**RE: DA/10/1049 – PROPOSED MOSQUE  
NO'S 158A & 164 CROUDACE ROAD, ELMORE VALE**

## **TRAFFIC RESPONSE REPORT – NUMBER 2**

### PROPOSED MOSQUE & COMMUNITY FACILITIES

### **158A CROUDACE ROAD**

FIGURE 1

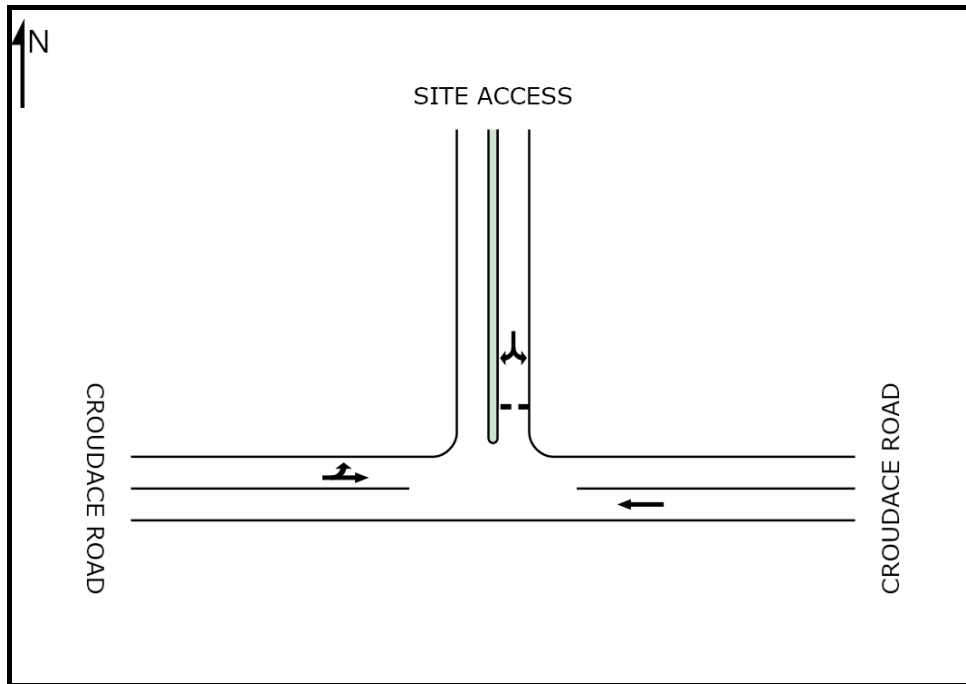
#### *1. Sidra modelling of the access during road network peaks;*

There is no prayer period identified for the Weekday am peak hence there is no need to model this period; for the Weekday pm peak Maghrib Prayer is scheduled and is stated to generate up to 25 worshippers; 25 trips exiting the site will be modelled.

TPK has also modelled the Friday Prayer period 1pm to 2pm for exiting traffic under the latest access design to confirm the intersection capacity; the arrival traffic is left turn in only and unopposed so modelling is not required.

The Movement Summaries provided below confirm acceptable operation conditions under the scenarios identified.

Figure 1 is the SIDRA geometric model base adopted.

FIGURE 2

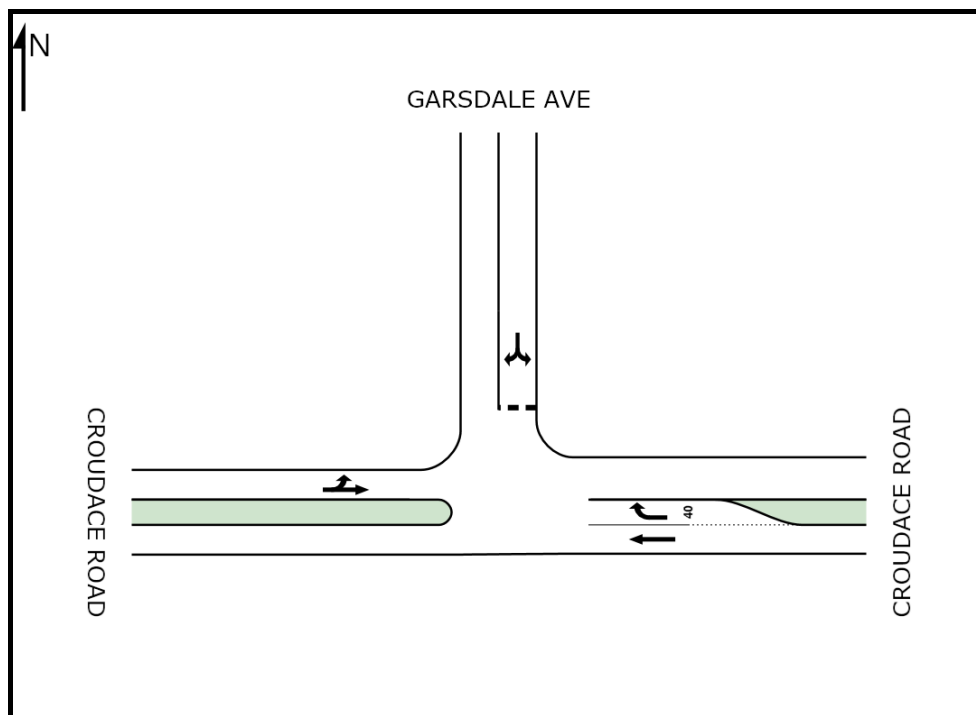
3. *Sidra modelling of the Garsdale Road / Croudace Road intersection pre and post development to determine if the development has an adverse impact on the operation of the intersection.*

SIDRA modelling has been undertaken for the pm peak with Existing Traffic and then with additional Arrival Traffic plus Friday Prayer (1pm to 2pm) Arrival Traffic added to Existing Traffic as the arrival scenarios have all potential traffic generations from the development travelling through the intersection due to the no right turn restriction into the site.

Figure 2 is the SIDRA geometric base adopted.

The model indicates that the side street potentially experiences unacceptable delay; the model does not take into account the platooning of Croudace Road traffic by downstream controls.

The outcome reinforces the fact that Croudace Road is approaching traffic volumes where all side street or driveway traffic will be subjected to delay to a level that alternatives will be required. It may be that a route strategy is developed by the road authority and/or it becomes accepted that side street traffic along the route will revert to left out and U-Turn manoeuvres to proceed on their trip, in the peak periods.

### **SITE ACCESS**

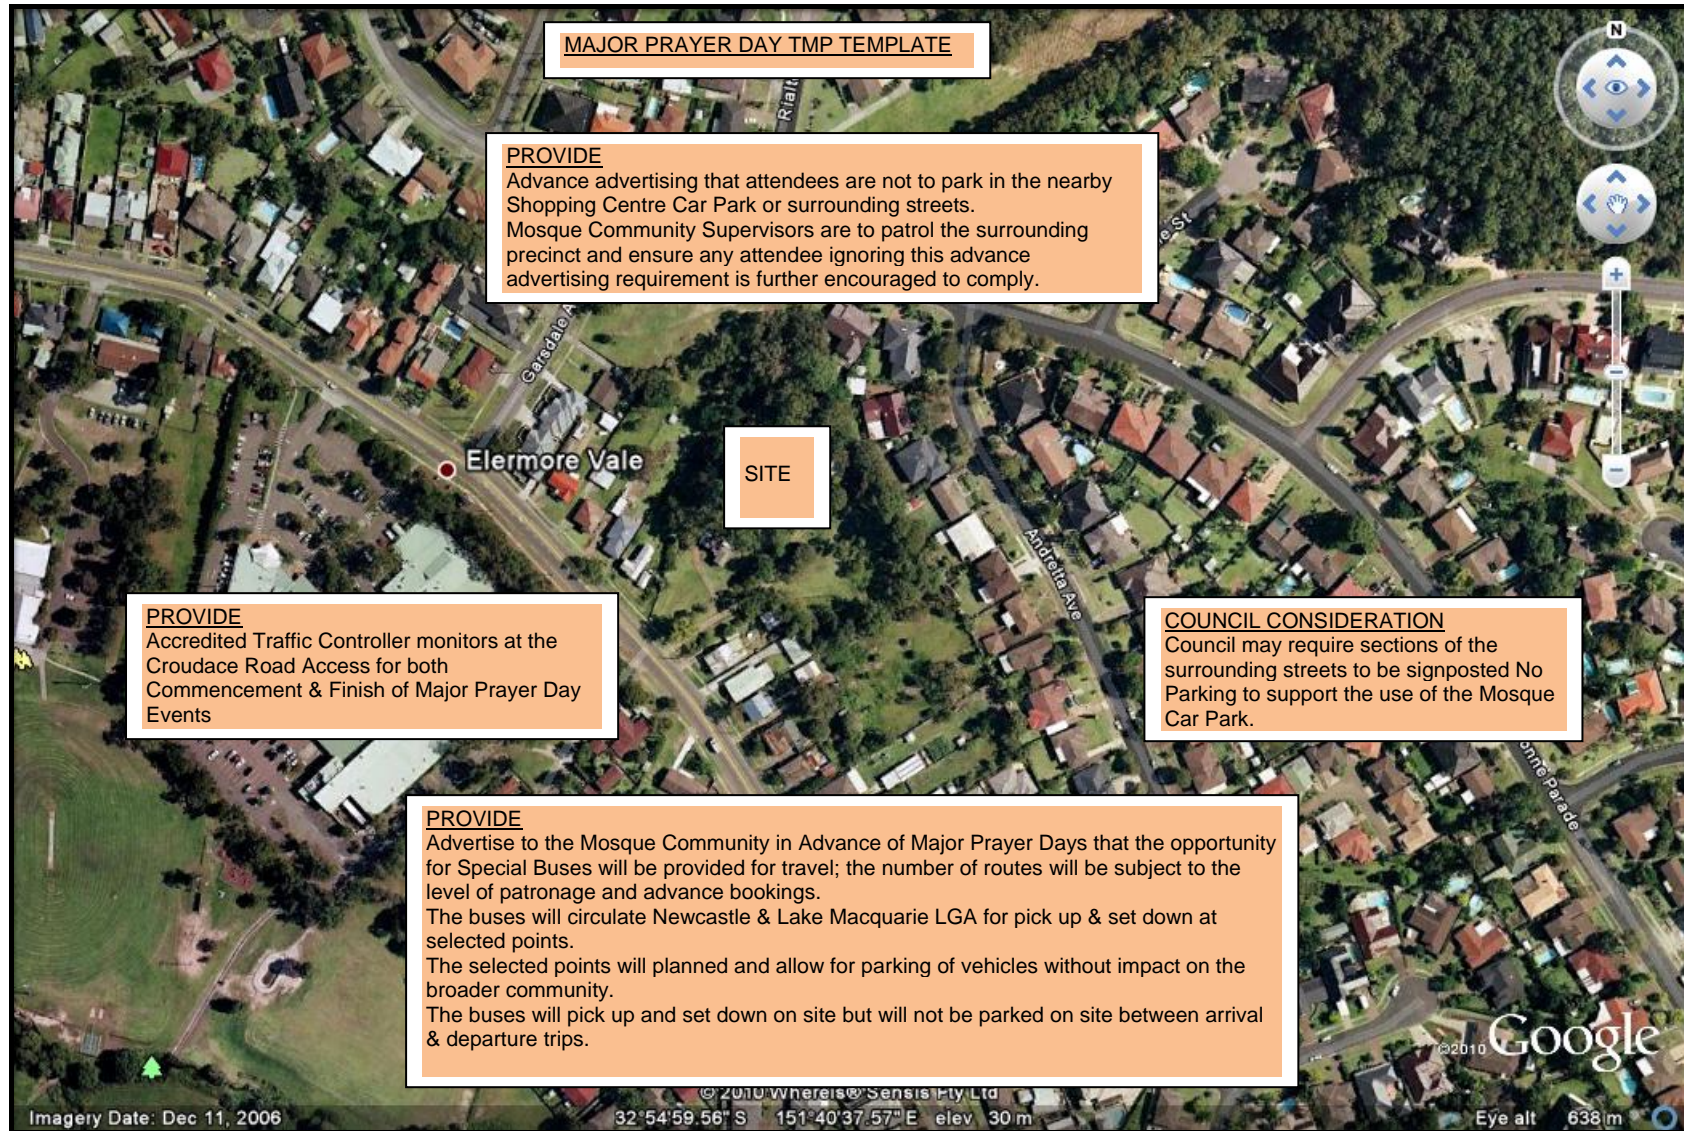
*In terms of access to the site the first concern I have with the proposed left turn in and left turn out proposal is that experience at other developments has shown that despite the provision of channelization within the access and signposting there is still a significant number of drivers who will still opt for the easy access option when travelling from the east to the site of ignoring the signage and turn right into the site. Experience has shown the only way to suitably enforce the no right turn is to physically restrict it with a central raised concrete median or barrier. A concrete median in this location is not considered feasible due to the narrowness of Croudace Road and the major impact it would have on existing adjacent property accesses. The applicant should address how the development can deal with drivers ignoring the signposting at the access.*

*The other concern I have with the left in and left out only access that needs to be considered is how drivers forced to head in the opposite direction when either entering or exiting the site turn around to head in the direction they need to. Whilst it is acknowledged some regular users will adjust their travel routes to suit there will still be significant numbers of first time visitors who will be faced with a decision as to how to enter or exit the site from opposite directions. Driver behaviour unfortunately is to take the easiest and quickest option rather than the safest. Therefore apart from ignoring the signposting at the access, as discussed above, they will generally look to the nearest location, usually an intersection to undertake a u-turn movement. The traffic report should identify where these manoeuvres are likely to happen and comment on whether these are safe movements or not.*

*In carrying out this assessment the applicant, through the traffic consultant might consider whether catering for the right turn out of the site is a safer option than a u-turn at the next intersection to the east. Construction of the Garsdale roundabout should also not be assumed unless the applicant proposes to construct it to mitigate the safety concerns regarding visitors to the mosque doing a u-turn manoeuvre at the intersection to access the site due to the left in only restriction at the entrance. Council at this stage can provide no guarantee's as to the date of construction of the roundabout and it is considered that there is not sufficient nexus for Council to require the applicant to construct the roundabout as a result of the impacts of the traffic generated by the development.*

The Applicant has adopted Council's recommended layout for site access as indicated in their March 2011 letter where the only movement restricted is the right turn into the site; SIDRA modelling earlier in this report has been based on that geometric layout.

The applicant adopting that access arrangement does not alter the submitted plans. The only change is to the shape of the island and signposting at the intersection of Croudace Road and The Site Access; TPK has provided Plan TPK-CR-01 in Appendix A of this report to confirm the minor change. The key factor at this time is to obtain approval to the concept for the access layout; the detail design prepared after DA approval will need to be approved by Council.

The result is that of the concerns expressed by Council in this section of their letter, with respect to effective control of restrictions that the only restriction remaining is No Right Turn into the site. TPK recommend two initiatives that can be DA conditioned and would support the right turn restriction:

- No Right Turn sign to include schematic indication of the Cardiff Road roundabout 400m Ahead to do a U-Turn.

- Site Access exit lane to be closed by church management (Traffic Cones at 0.5m centres) between 12noon and 1.30pm for Friday Prayer.

Figure 1 – Revised Acoustic Fence Location

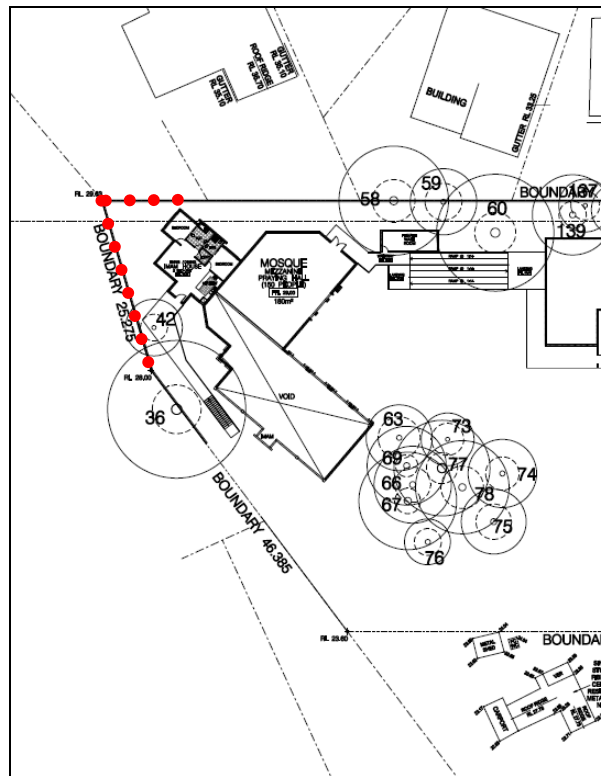
**Paragraph 1 relates to noise emissions to the north west of the site**

As described in the previous letter response to council, a review of the layout and the proposed activities on the site has shown that, due to acoustic screening effects of the structure of the mosque and, more significantly, the Imam house it would be possible to replace that part of the proposed fence as shown (dotted in red) below in **Figure 1**. Sections through the mosque are attached as Appendix I to this letter.

The sections show that noise emissions from the mosque are effectively screened to the north west by the structure of the Imam house. Noise emissions in this direction will be virtually inaudible.

Figure 2 - Pre 7am Car Park Exclusion Zone

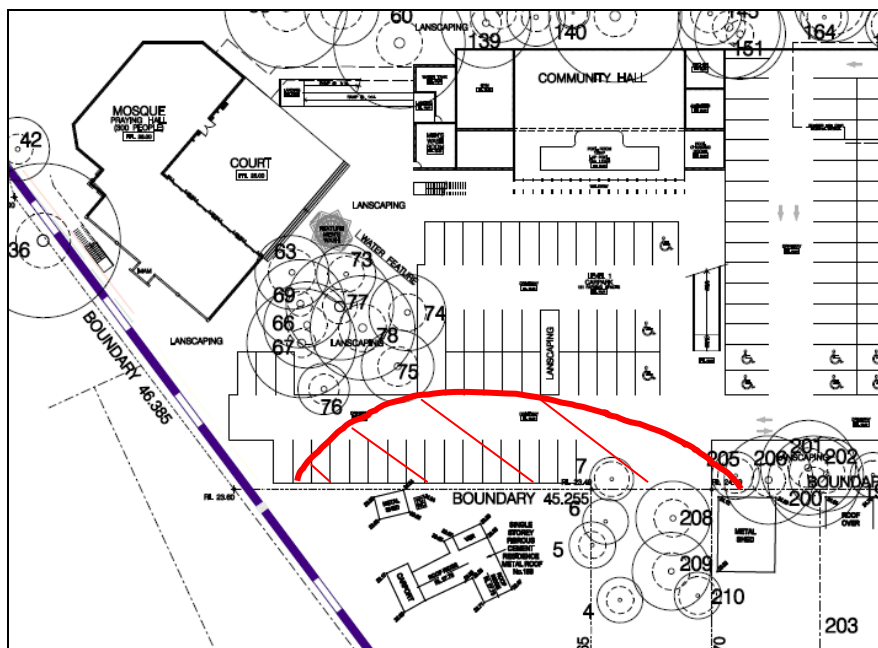
**Paragraph 5 relates to early morning car park usage**

It is recommended that permanent posts (or a similarly effective method) will be erected at the location of the car parks in the “exclusion zone” as indicated previously (and shown below in **Figure 2**). A chain, or similar method, linking the posts must be in place to ensure no parking is available in the zone before 7.00 am.

In addition to this it is recommended that a suitable sign be erected informing the congregation of the requirements to avoid those car parks in the exclusion zone during the early morning and of the need to respect the acoustic amenity of neighbours and move quietly towards the mosque. This message must regularly be verbally reinforced by the Imam.
